Docket Item #3  
BAR CASE #2005-0231

BAR Meeting  
November 2, 2005

**ISSUE:** Permit to Demolish and Capsulate

**LOCATION:** 715 South Lee Street

**Figure 1** Existing rear elevation

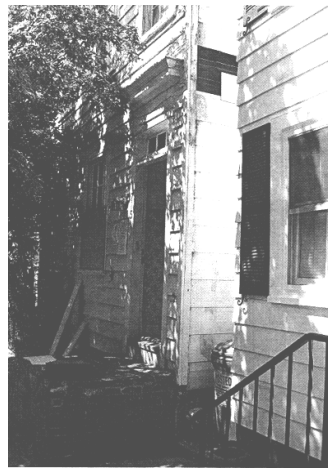
Staff believes the proposed demolition and capsulation is generally acceptable and does not rise to the level of the above criteria. The fact that the rear wall of the original main block will be entirely demolished is somewhat troubling. However, approximately 2/3 of this wall has been capsulated for over 25 years by the existing rear addition and the exposed portion of the original rear elevation was further altered by the circa 1978 installation of a french door on the first floor.

The area of *new* capsulation on the rear wall of the main block is actually quite modest: approximately 110 square feet. The rear wall of the historic main block is not visible from the public right-of-way. The other major area of capsulation and demolition is at the rear of the non-historic addition. This area is also not visible. The proposed demolition and capsulation to alter the fenestration on the south elevations of the main block and 1978 addition, which are at partially visible, is relatively minor. For all these reasons, Staff finds the proposed demolition acceptable.

**Figure 4** Front elevation detail

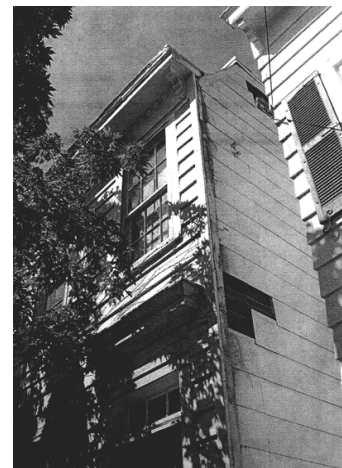
On the existing main block, the existing fenestration, consisting of twelve matching windows, six per floor will be altered in a number of ways. First, a new window opening is proposed at the front of the first story. The area of demolition required for this new opening is approximately 21 square feet. Secondly, the last four windows toward the west end of the elevation will be shifted in location and/or altered in size. On the rear addition, the existing door on the first story and window on the second will be replaced by large areas of ganged windows. The total amount of demolition and capsulation required by these window alterations has not been calculated.
